Re: Zero Canal Plaza Development
Level II Site Plan Application – Response to Comments

On behalf of Cow Plaza 1 LLC, we present the following responses to comments provided by staff and peer reviewers on the project. We have included each of the original questions below in italics.

Engineering Review memo from Stephen Bushey, dated August 1, 2016

CS110 / 111

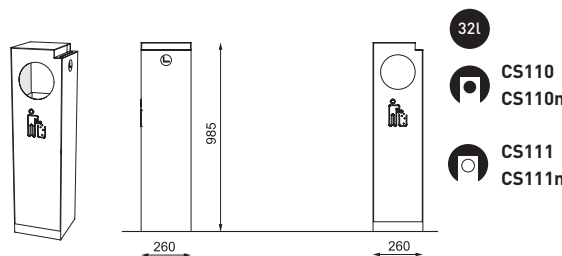
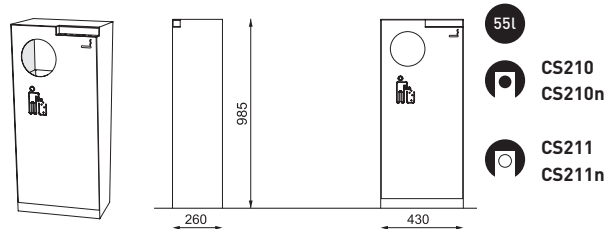
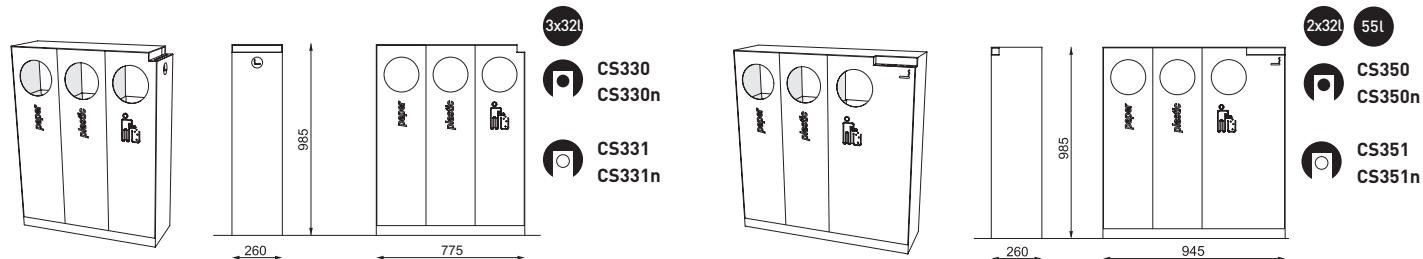
- *Provide more details on the following:*
 - *Solid waste/trash management – location and type of receptacles*
 - The enclosed plan shows proposed locations for trash receptacles. A cut sheet for the proposed receptacles is also enclosed.

2. *Will any bike racks or other site improvements besides benches be provided? Will there be provisions for trash/garbage containers in the plaza, at least seasonally when there may be some outdoor dining?*

The enclosed site features figure shows bike racks and trash containers. A cut sheet for the trash containers is also provided.

LT.2

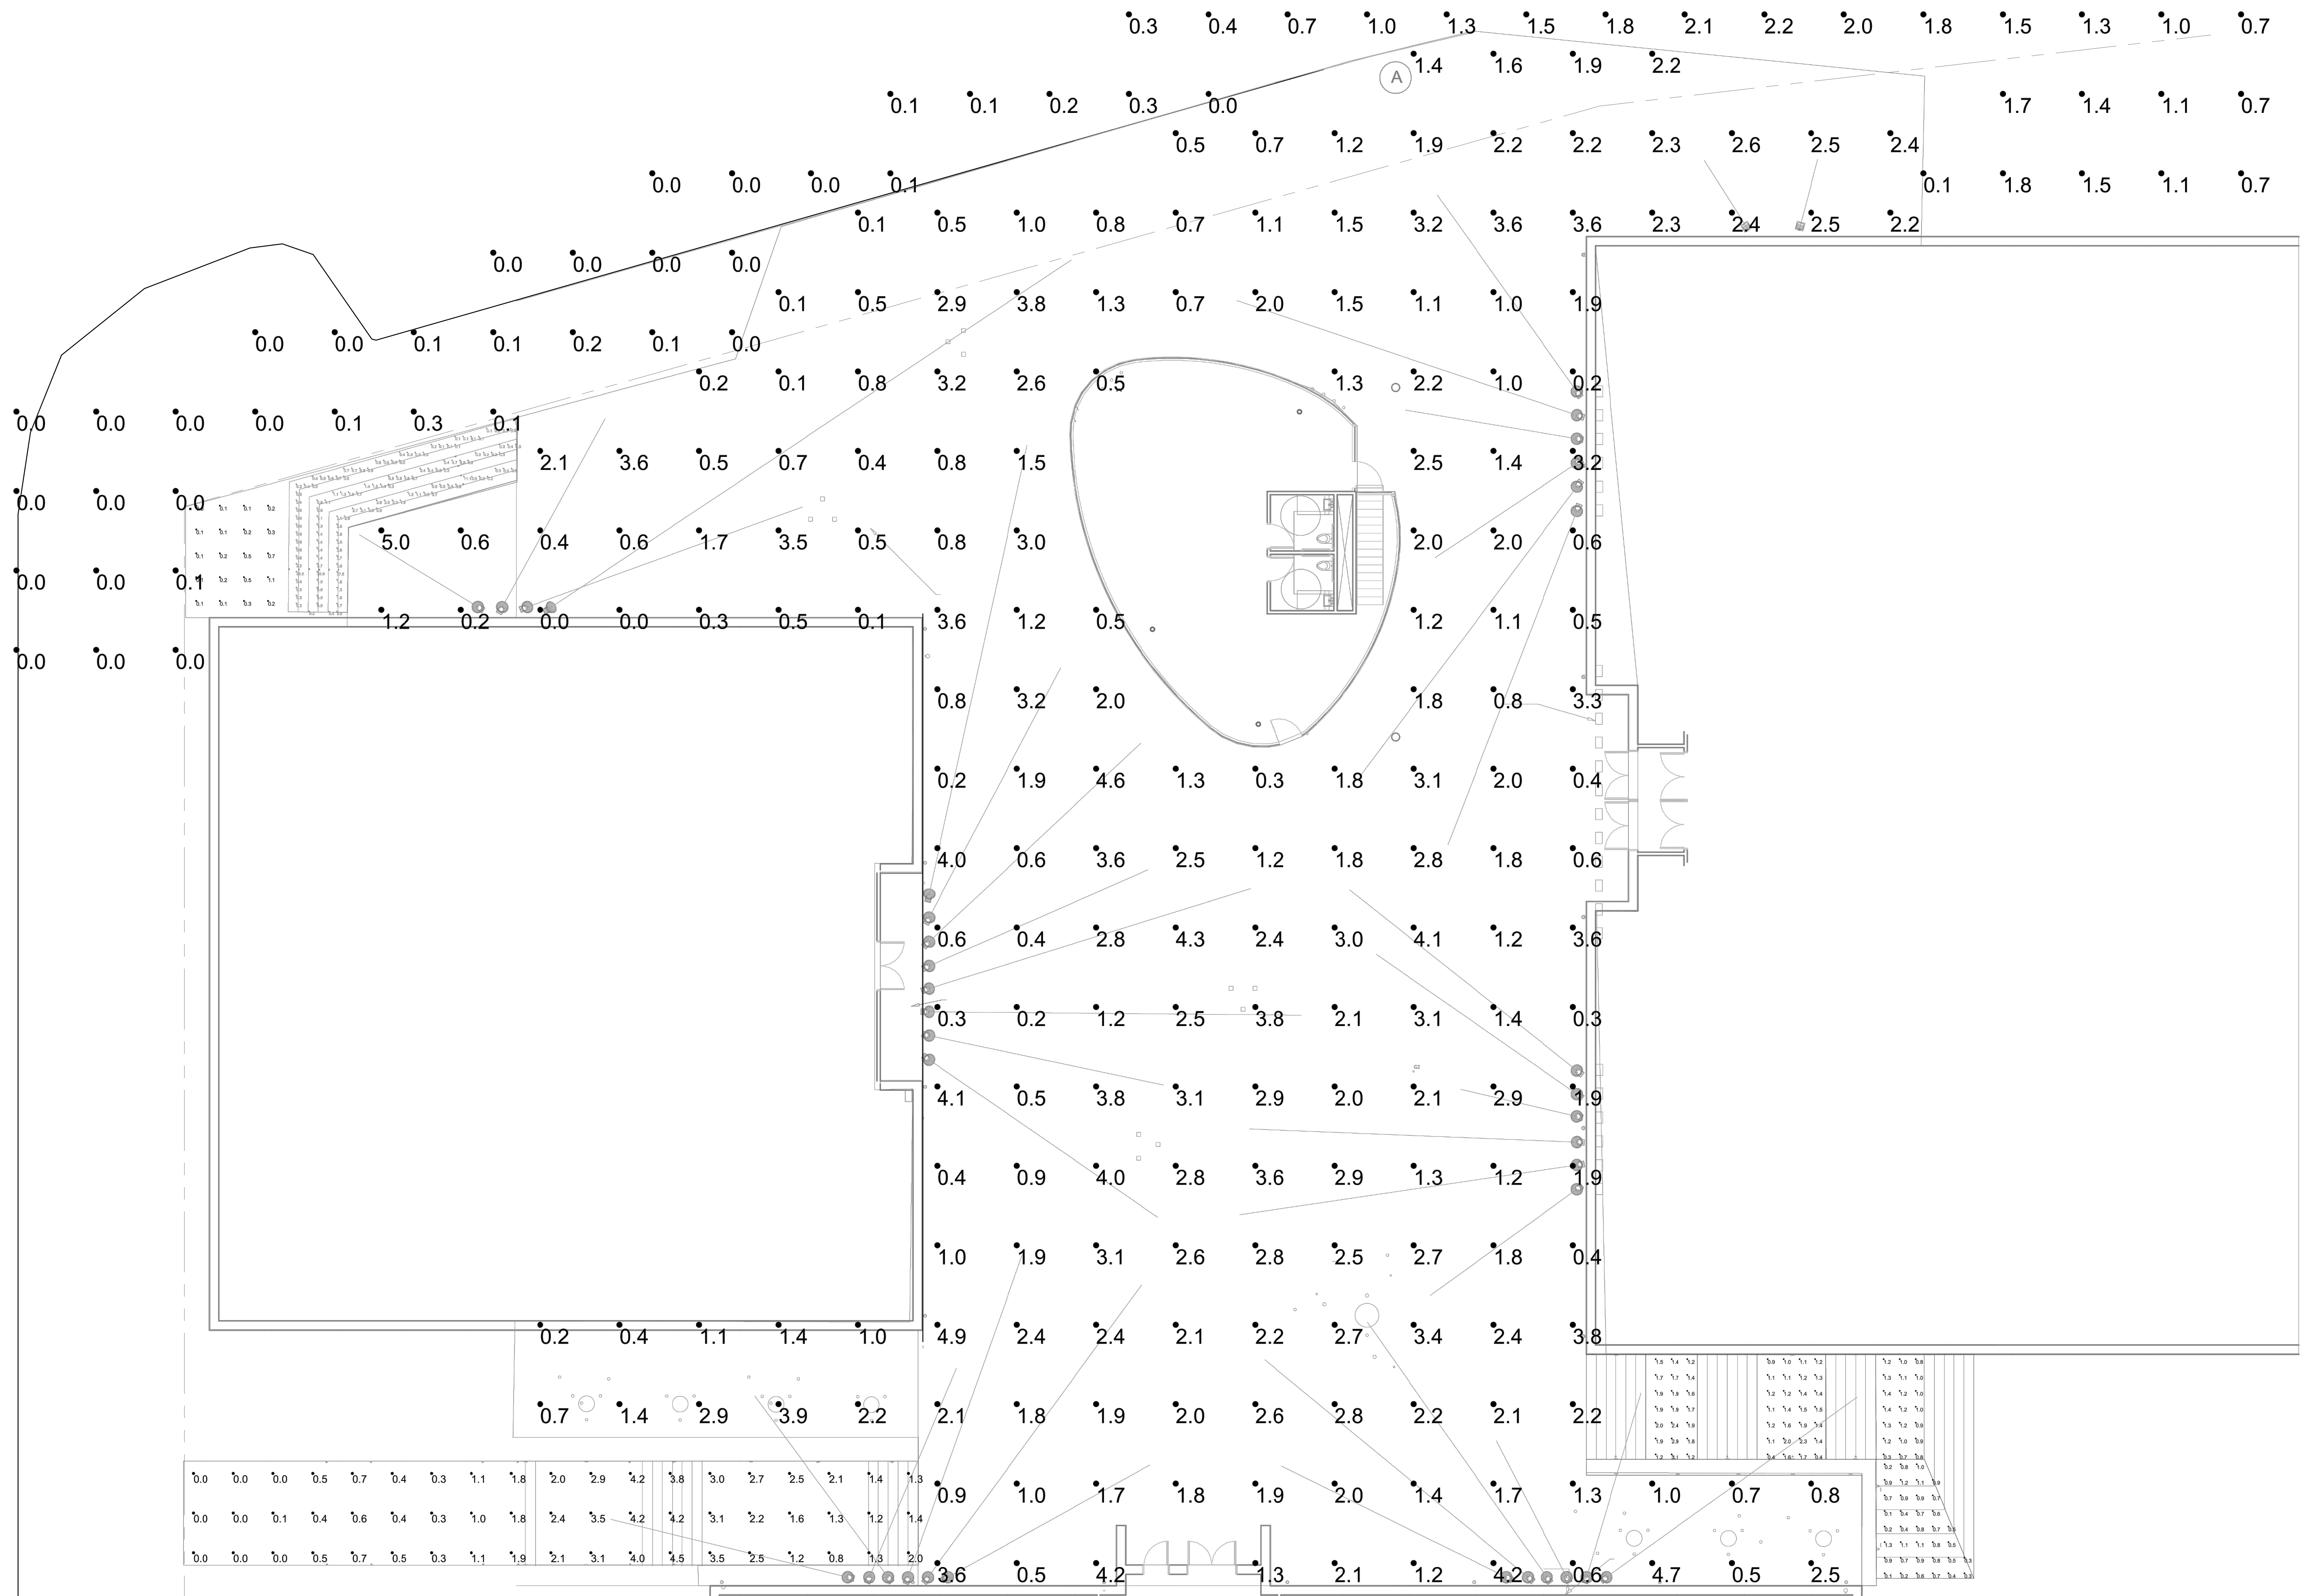
- *Photometric plan of site lighting*
 - A photometric plan is enclosed.
 - *Snow removal and/or storage plan*
 - The plaza owner will continue to contract with an outside contractor for the removal of snow from the plaza as they do currently. The contractor will use small-scale equipment within the plaza to clear all snow from the plaza to provide access between the existing and proposed buildings during the winter months.

- *Will both entries be active?*
 - Both entries are anticipated to be active, but this will be somewhat dependent on the final use of the site.
- *More information is requested about lighting levels, trash receptacles, and bike parking.*

- A photometric plan has been enclosed. A plan showing proposed trash receptacle locations and the location of the proposed bicycle parking is attached, as is a cut sheet of the proposed trash receptacles.

C-200

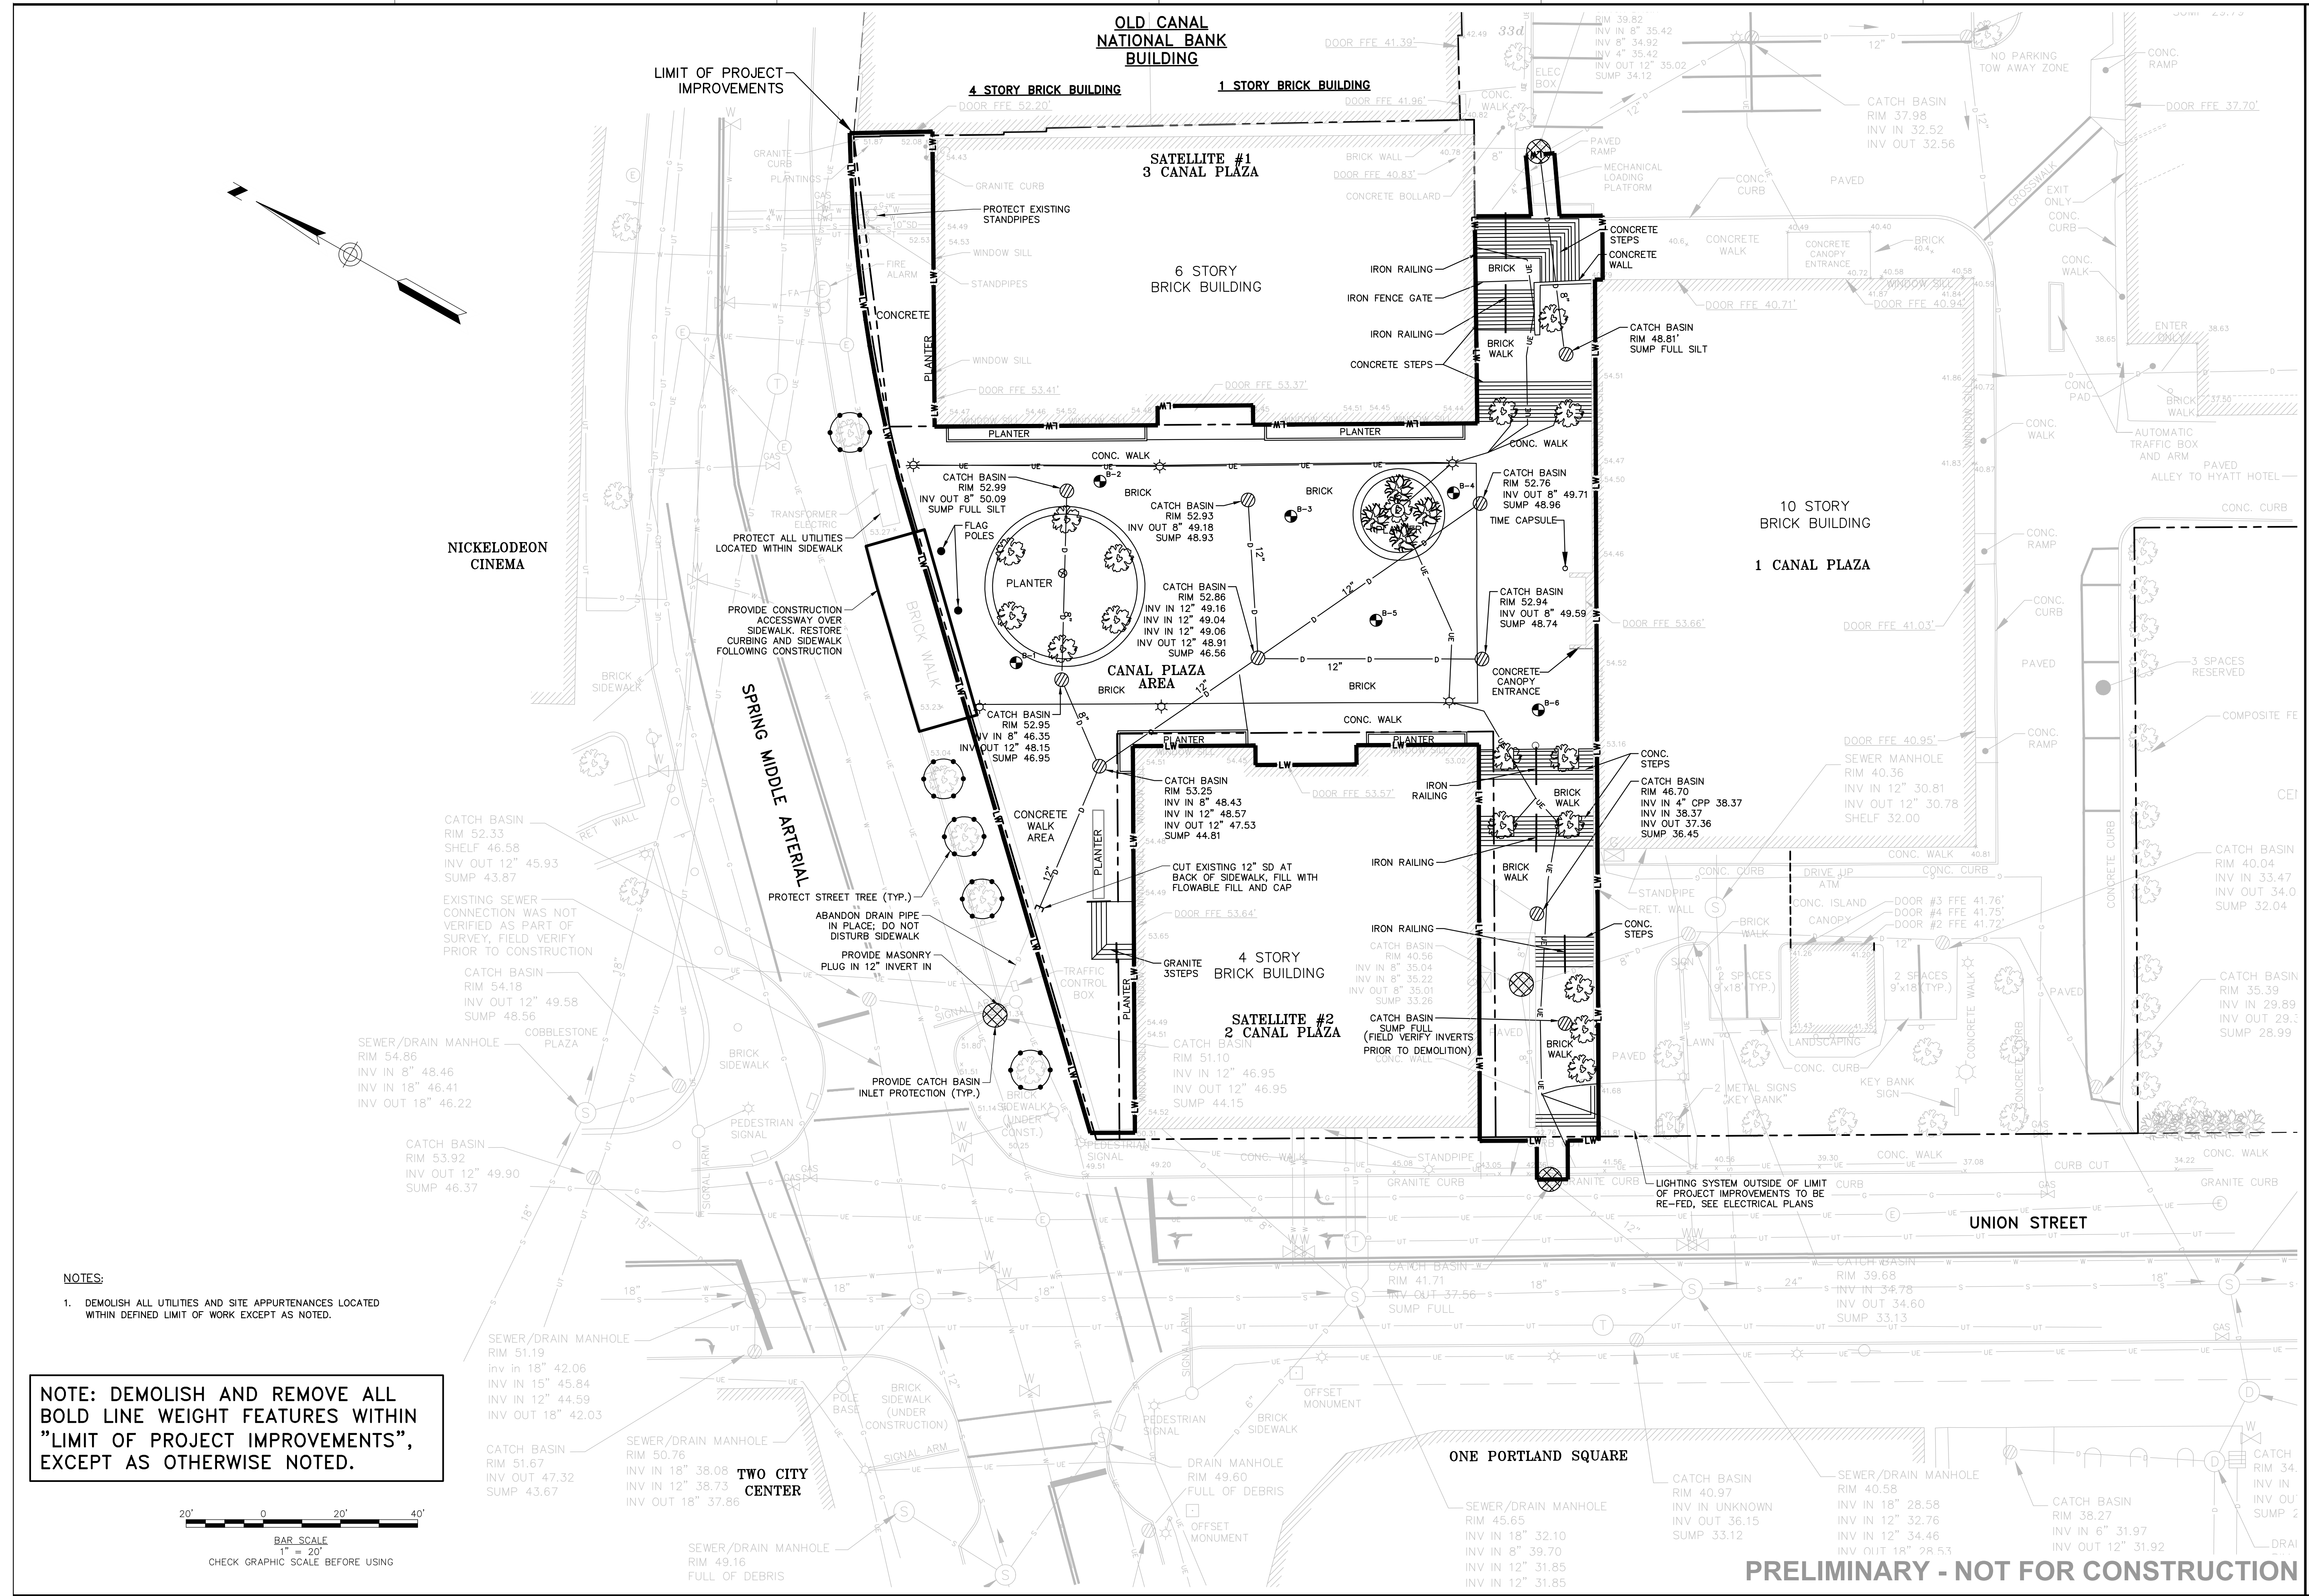
1. *The Plan indicates “Demolish” for anything in bold line work. Does Demolish mean remove and/or abandon in place?*

2. *The Public Works Department should weigh in on the abandonment of the 12” SD off the Middle Street arterial. The plan calls for the placement of flowable fill in the pipe and capping.*

The PWD may want a masonry infill on the pipe entry into the existing CB or some other form of permanent blockage.

- 3. It is unclear what is happening with the existing 8" SD from the existing CB located on the south side of 1 Canal Plaza that connects to the drain system within the West stair area. Does this line need to be maintained? If so, it should be verified there will be no conflict with the proposed Pipe CB2.*

- 4. There is a CB within the West Stairs that doesn't show an outlet. The CB will be removed and we assume any SD will also be removed?*

On Drawing Sheet C-200, the term “Demolish” includes the removal of all features. The words “and remove” has been added to provide additional clarity. The specific requirements of demolition and removal are also addressed in the construction specifications as part of the project Contract Documents.

The notes provided for the existing catch basin include the installation of a masonry plug as part of the demolition.

The existing 8" SD connection will be maintained. Based on the existing inverts of the two connected catch basins and the inverts for the proposed Pipe CB2, the existing stormdrain will be lower than the proposed, and there will not be a conflict.

The CB within the west stairs will be removed. A note has been added to field verify stormdrain connections prior to demolition. Field modifications will be made as necessary.
